# **Official statement about the pitch control characteristics on SL-1210MK7 before and after the redesign**

This document has been made in order to explain and inform about the pitch fader characteristics of the SL-1210MK7 in its original version from June 2019 and after a redesign which has been performed and got effective with all SL-1210MK7 units delivered from July 2020.

## Technical explanation of the new pitch slider characteristics

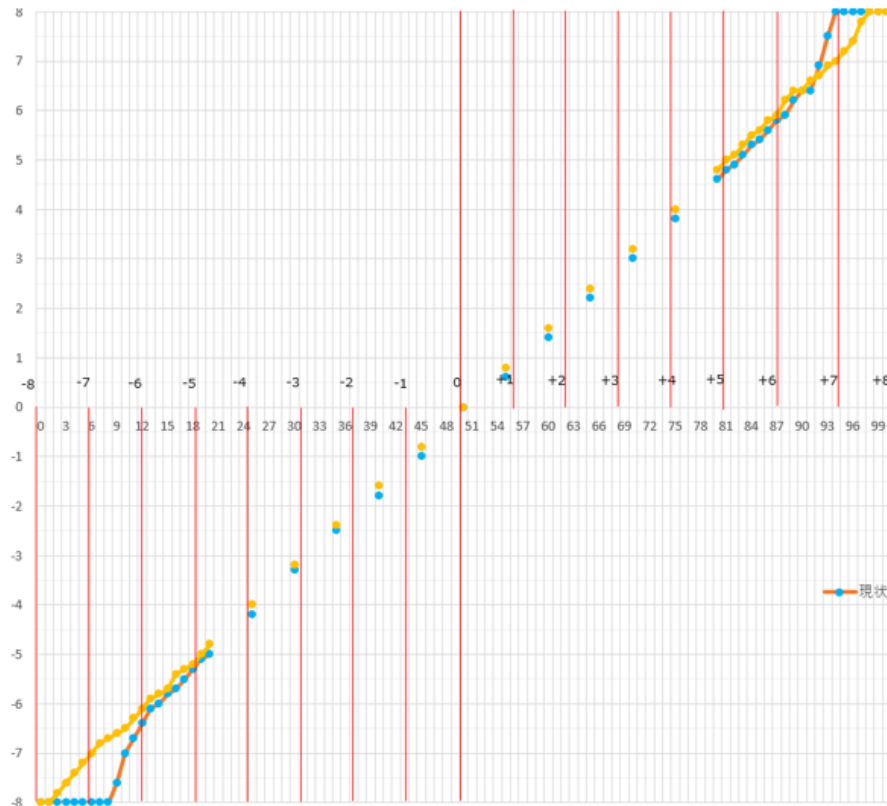
But such sliding resistor has another issue. The resistance characteristics are not always linear, especially around both ends. Typically, the characteristics begin to lean around the 6%-7% pitch position. So by the combination of this non-linearity issue and the 8% adjustment at the actual slider position of 7.5%, the dead zone expands to 7-8% at most units out of the production.

This design however will ensure reaching  $\pm 8\%$  speed variation but on the expense of a non-linearity between  $\pm 6\%$  and  $\pm 8\%$ .

Former design(Blue plots):

On the main unit, the actual speed has already reached  $\pm 8\%$  at the slider position of  $\pm 7\%$ . There is no change in speed between scale positions  $\pm 7\%$  to  $\pm 8\%$  ("Dead Spot").

Updated design(Yellow plots):

When the pitch slider on the main unit scale is set to  $\pm 7\%$ , the actual speed is almost the same  $\pm 7\%$ . Linear change characteristics best as possible have been realized.
